BOROUGH OF DEMAREST

REGULAR MEETING AGENDA

RE: Application No. JPB-25-007
32 Brookside Avenue (Block 14 / Lot 759.02)

32 Brookside Avenue
Block 14, Lot 759.02
Borough of Demarest, Bergen County, NJ
Joint Land Use Board Application - Engineering Review
Colliers Engineering & Design Project No. DEZ0046

Historical Imagery - Conditions from 2014 - 2017

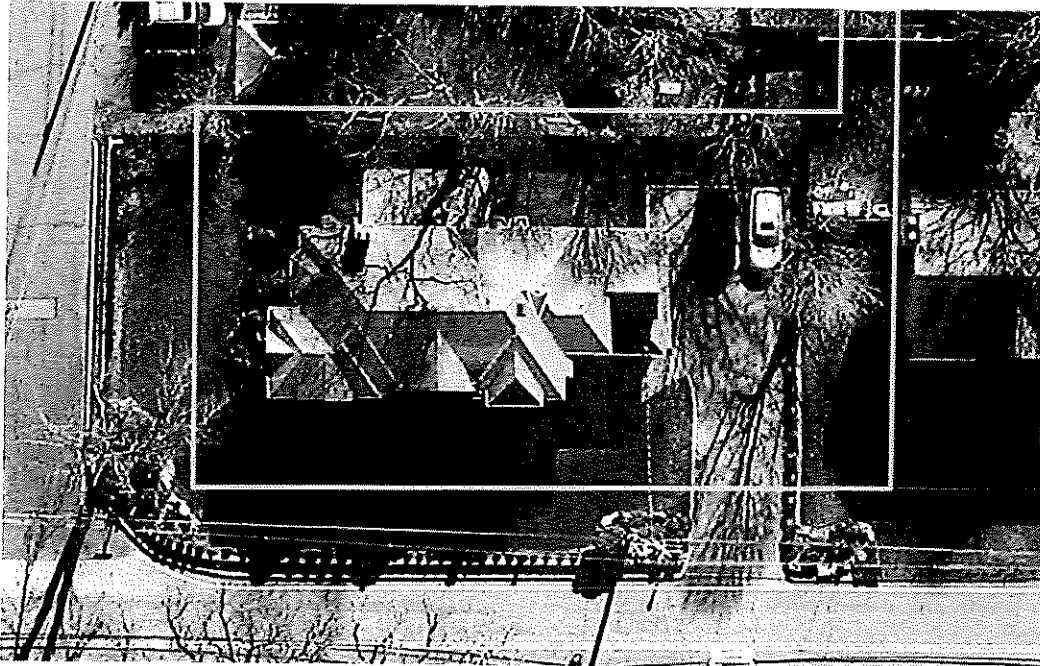
- G. Historical Imagery
1. We note that historical imagery suggests that the dwelling, rear, patio, driveway, and walkways existed as they are shown dating back to 2014 (no imagery is available prior to this date). See imagery below.

2. It appears an expanded rear patio area was constructed sometime in 2017 which occupied almost the entire rear yard area. This patio was removed in late summer/early fall of 2024. See imagery below.
